# UNITED STATES PATENT AND TRADEMARK OFFICE

APPLICATION NO.	FILING DATE	FIRST NAMED INVENTOR	ATTORNEY DOCKET NO.	CONFIRMATION NO.
10/627,679	07/28/2003	Andreas Fleck	202-067	4589

## Office Action Summary

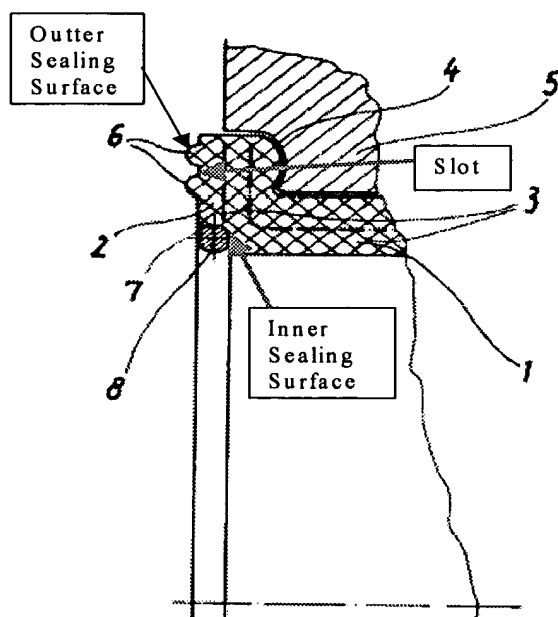
the flange collars defining respective end sealing surfaces facing toward the slip-on flanges. Levivier et al does not disclose each of the end sealing surfaces being partitioned in radial direction into at least inner and outer concentric annular sealing surfaces by a peripherally extending slot formed in the end sealing surface; and, only the outer annular sealing surface being in sealing contact engagement with the slip-on flange corresponding thereto when the holding flange is drawn toward and secured to the corresponding slip-on flange. In the Figure below,

Pustelnik teaches each of the end sealing surfaces being partitioned in radial direction into at least inner and outer concentric annular sealing surfaces by a peripherally extending slot formed in the end sealing surface; and, only the outer annular sealing surface being in sealing contact engagement with the flange corresponding thereto when the holding flange is drawn toward and secured to the corresponding flange, to compensating relative movements of the pipes. As Pustelnik relates to pipe connections with elastomer compensating bodies, it would have been obvious to one having ordinary skill in the art at the time the invention was made to fabricate each of the end sealing surfaces partitioned in radial direction into at least inner and outer concentric annular sealing surfaces by a peripherally extending slot formed in the end sealing surface; and, only the outer annular sealing surface being in sealing contact engagement with the flange corresponding thereto when the holding flange is drawn toward and secured to the corresponding flange, to compensating relative movements of the pipes, as taught by Pustelnik.
